**ADDENDUM NO. 1**

**ANNUAL CURB & GUTTER FOR STREET RESURFACING PROJECT  
PROJECT NO. 24509**

**ANNUAL CURB AND GUTTER FOR STREET RESURFACING PROJECTS**  
SANTA RITA ROAD AND W. LAS POSITAS BOULEVARD

DWG NO. **A6-1**  
ADDENDUM 1

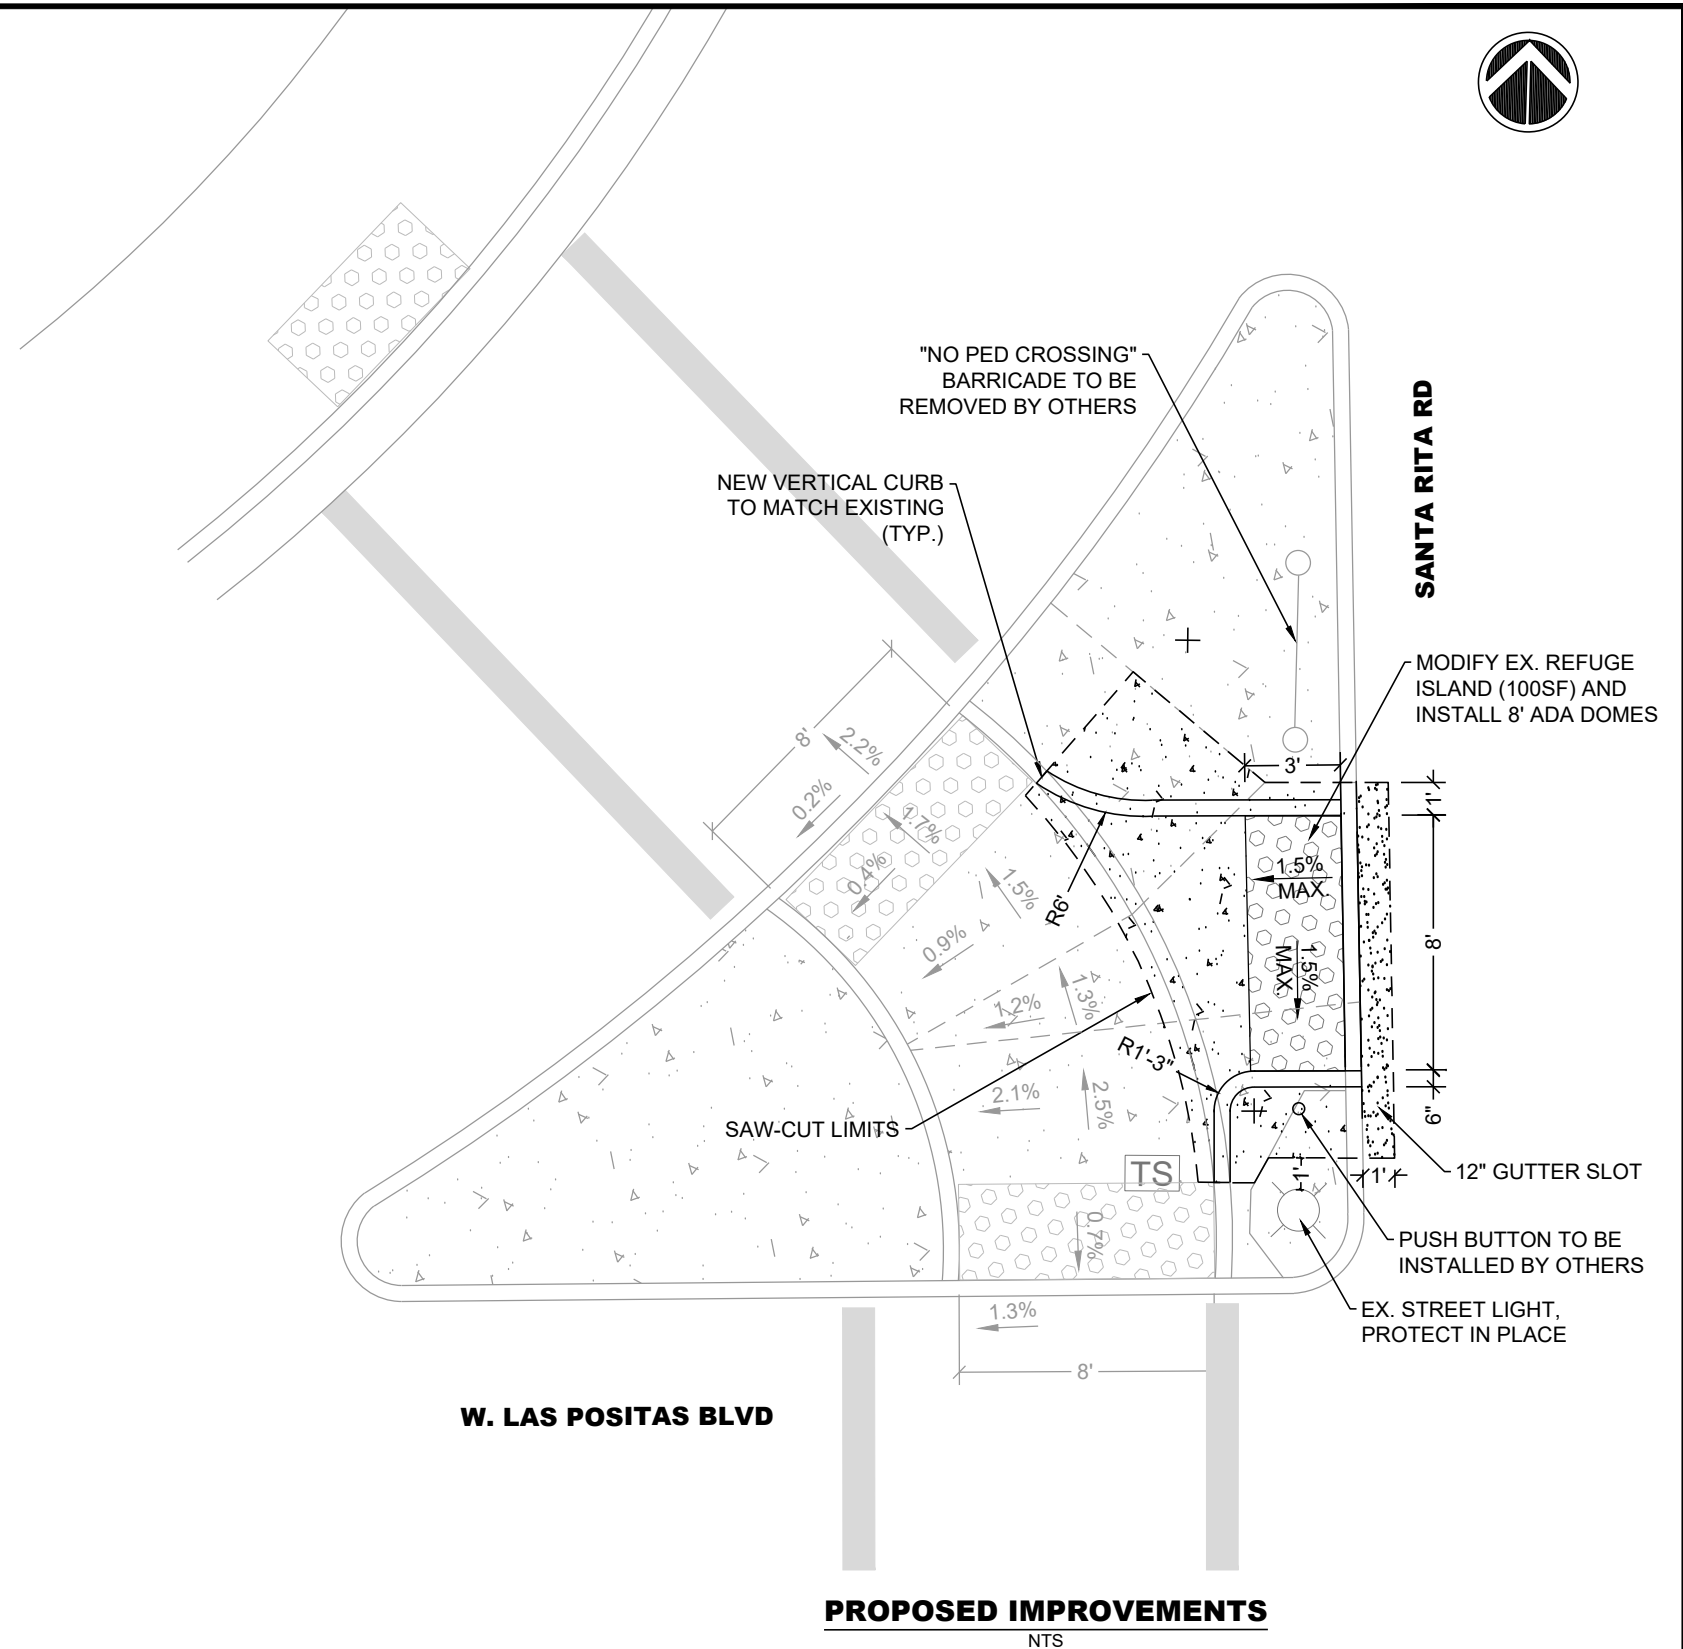
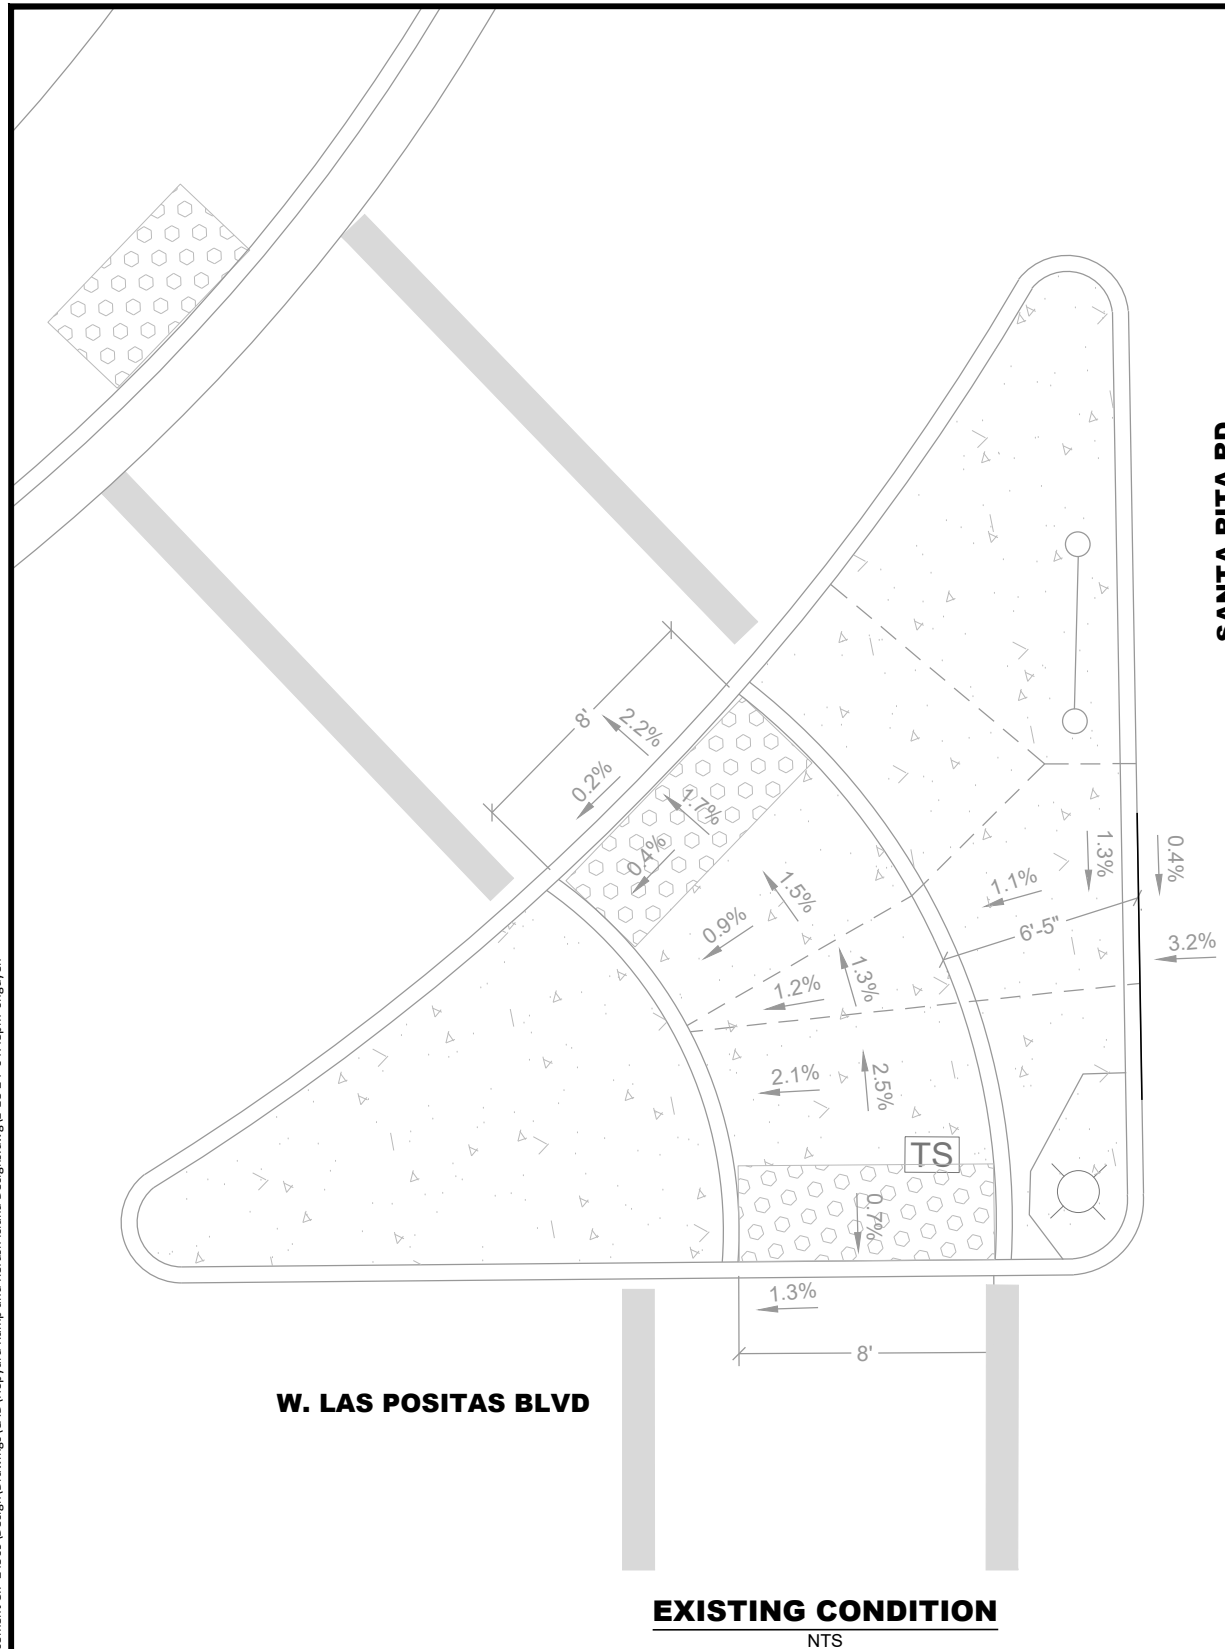
REV.	DATE	DESCRIPTION
1	1-18-24	ADDENDUM 1: ADDITIONAL WORK
